Amendment No. 0004
01 April 2002

SUBJECT: Amendment No. 0004 to Specifications and Drawings for Construction of Consolidated Lodging Facility, Phase III, Minneapolis St. Paul - International Airport, Air Force Reserve Station, MN.

Solicitation No. DACA45 02 B 0008.

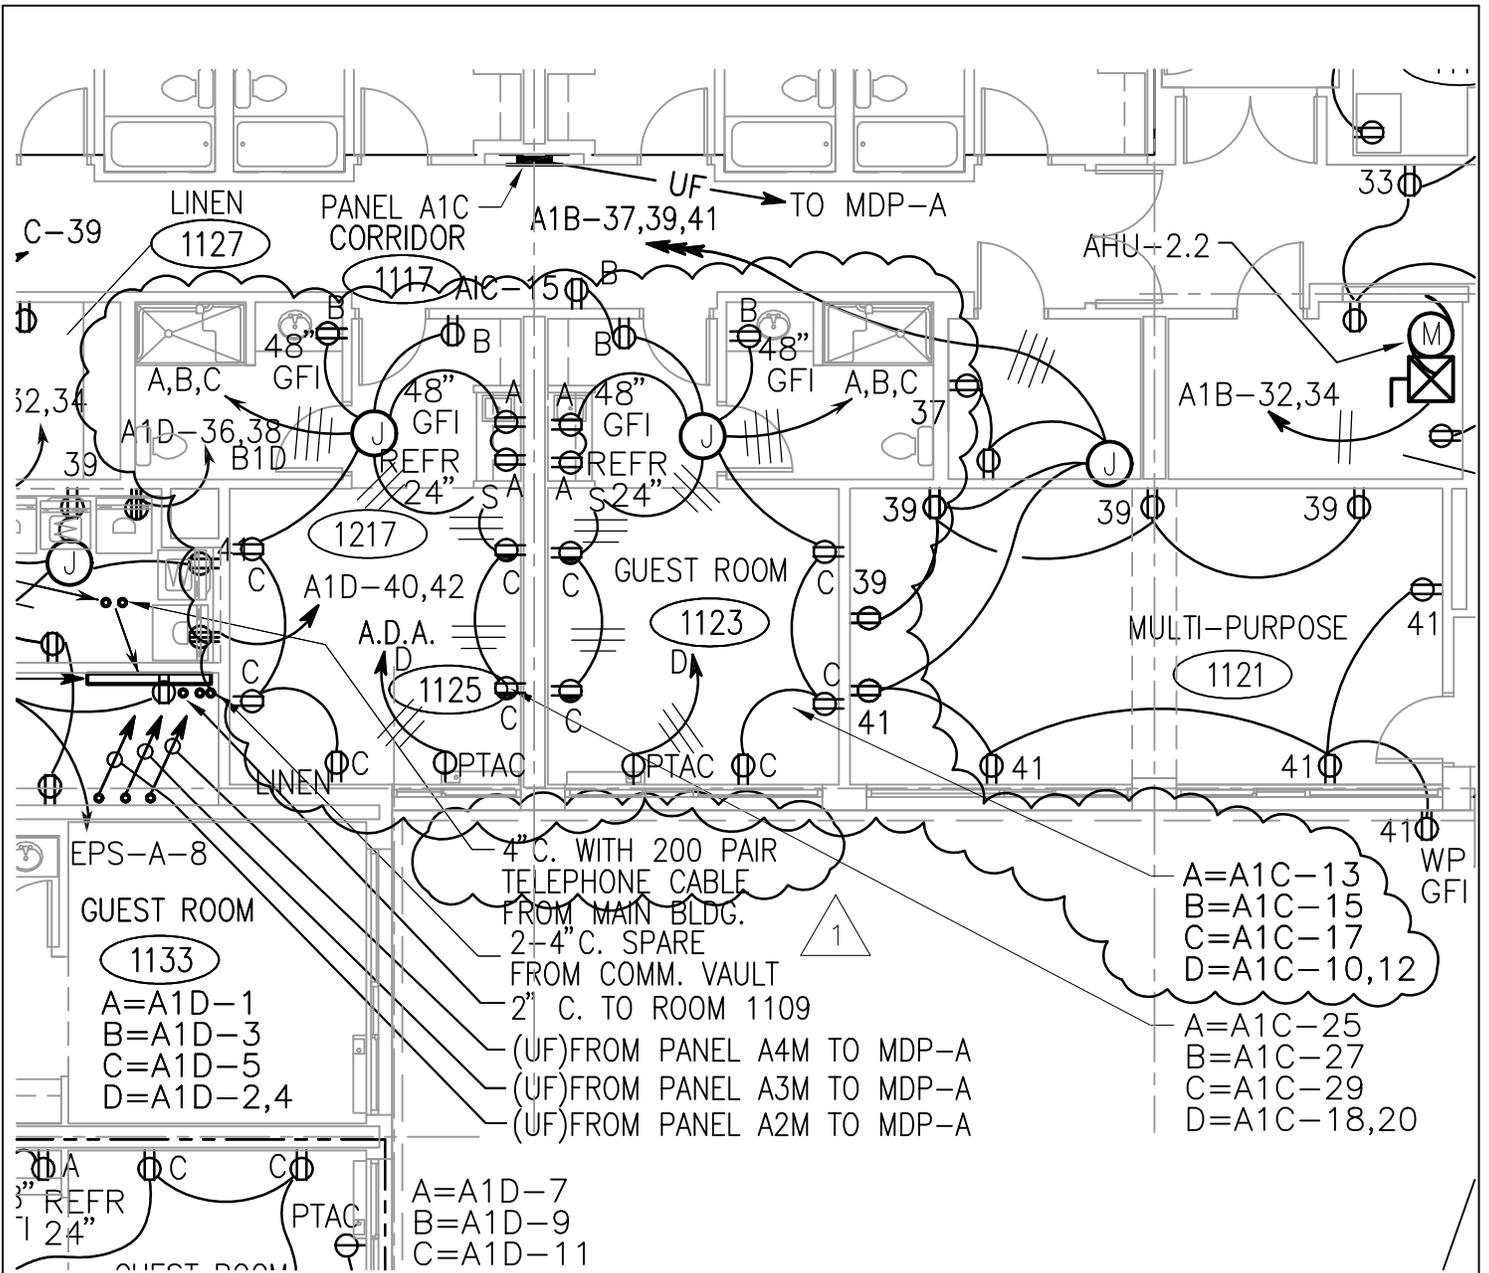
2. Drawing E1.3 (1st Floor and Basement Lighting Plan)
 - a. Provide lighting for ADA Rooms 1125 and 1123 per the attached sketch E9.
 - b. Provide lighting for Room 1128 per the attached sketch E9.
3. Drawing E1.4 (2nd and 3rd Floor Lighting Plan)
 - a. Provide lighting in ADA Rooms 2122 and 3122 (revise room numbers to be 2125 & 3125 to match architectural drawings) per the attached sketch E9.
 - b. Revise lighting for Room 2128 and 3128 per the attached sketch E9 (lighting to be similar to Room 1128).
4. Drawing E1.5 (4th Floor Lighting Plan)
 - a. Provide lighting in ADA Room 4125 per the attached sketch E9.
 - b. Provide lighting for Room 4128 per the attached sketch E9 (lighting to be similar to Room 1128).

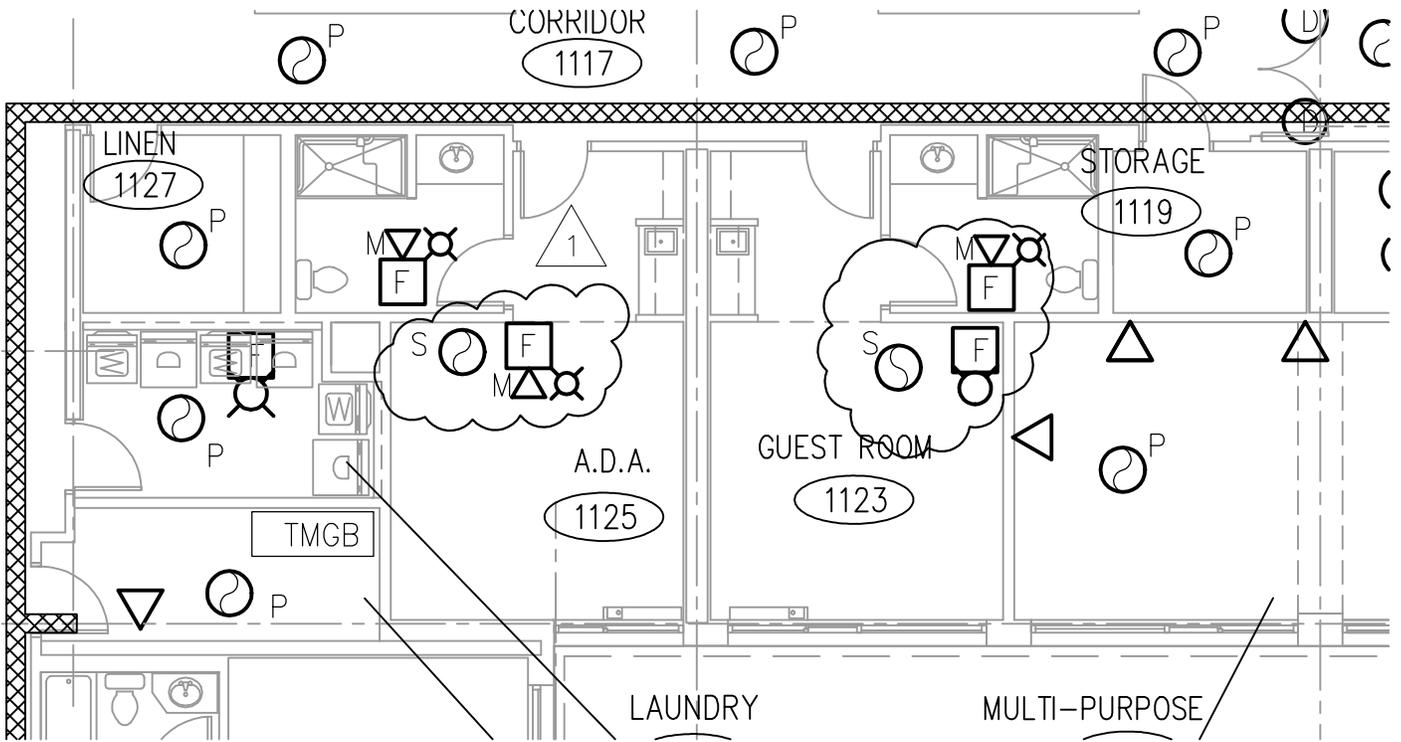
5. Drawing E2.3 (1st Floor and Basement Power Plans)
 - a. Provide power distribution for ADA Rooms 1125 and 1123 per the attached sketch E10.
6. Drawing E2.4 (2nd and 3rd Floor Power Plans)

- a. Provide power distribution for ADA Rooms 2125 and 3125 per the attached sketch E10 (power plan to be similar to Room 1125).
7. Drawing E2.5 (4th Floor Power Plan)

- a. Provide power distribution for ADA Room 4125 per the attached sketch E10 (power plan to be similar to Room 1125).
8. Drawing E3.3 (1st Floor and Basement Fire Alarm & Comm. Plans)

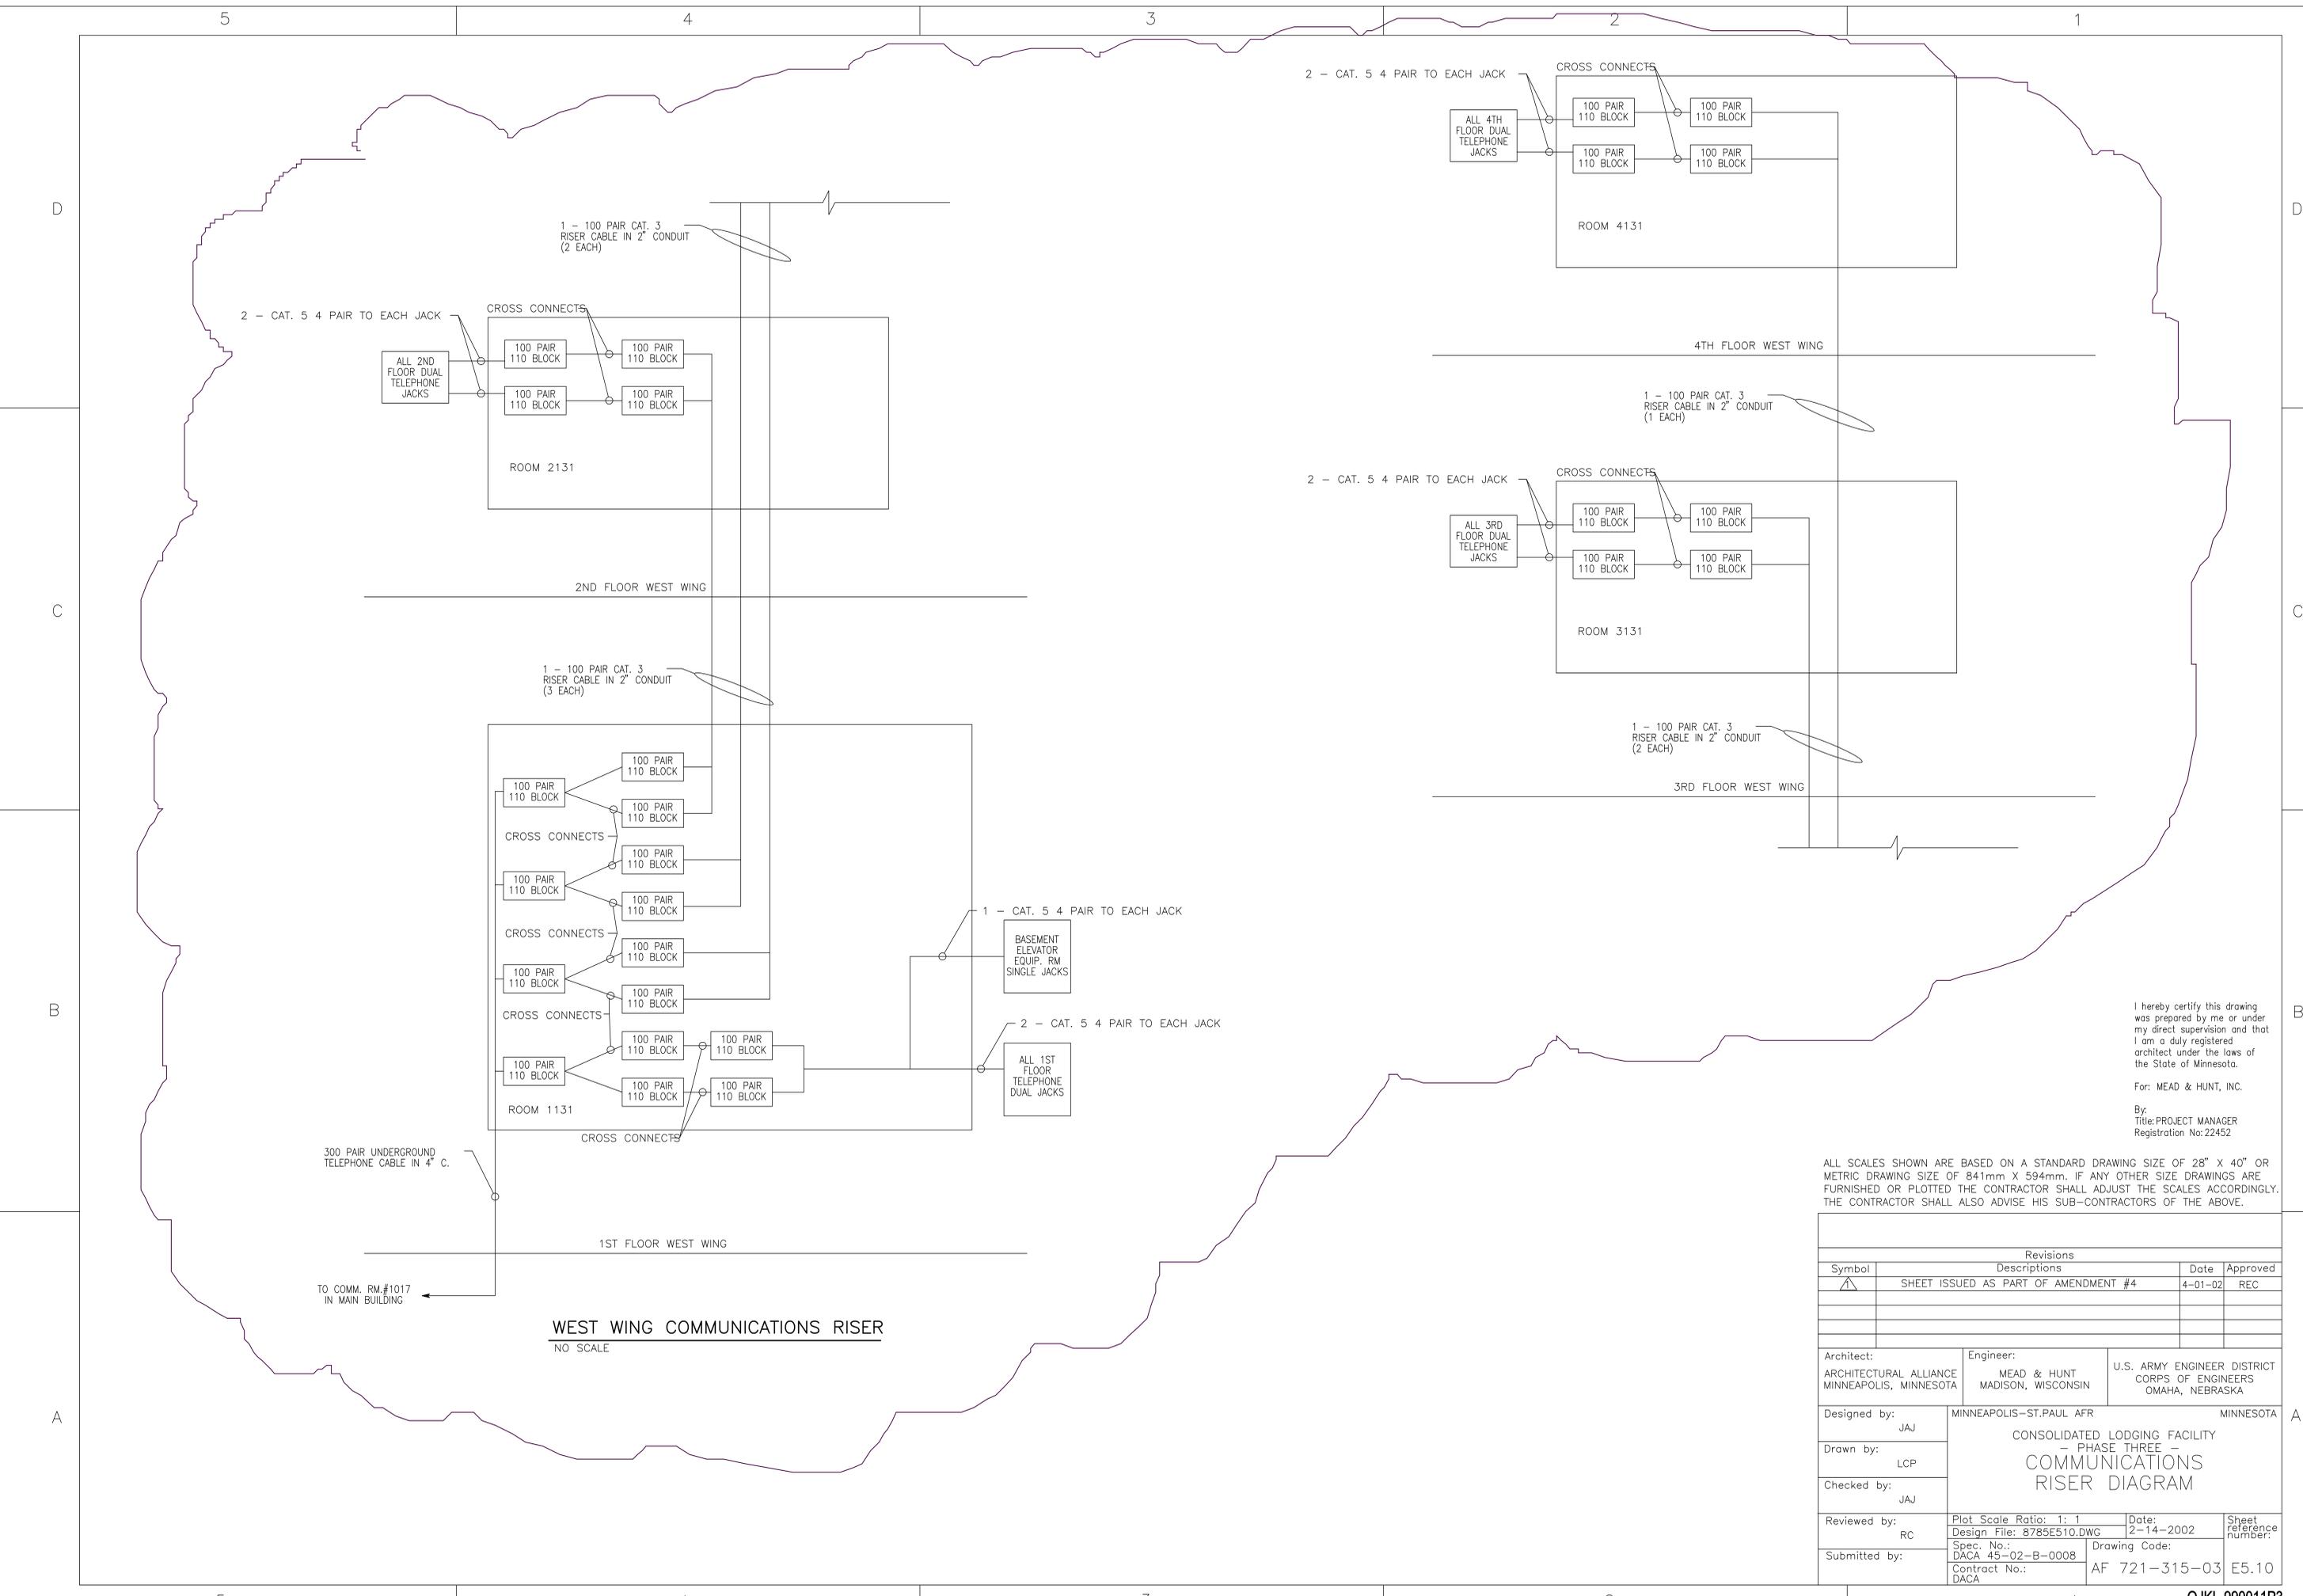
- a. Provide fire alarm and communication systems for ADA Rooms 1125 and 1123 per the attached sketch E11.
9. Drawing E3.4 (2nd and 3rd Floor Fire Alarm & Comm. Plans)

- a. Provide fire alarm and communication systems for ADA Rooms 2125 and 3125 per the attached sketch E11 (plan to be similar to Room 1125).
10. Drawing E3.5 (4th Floor Fire Alarm & Comm. Plan)

- a. Provide fire alarm and communication systems for ADA Room 4125 per the attached sketch E11 (plan to be similar to Room 1125).
11. Drawing E5.10 (Communications Riser Diagram)
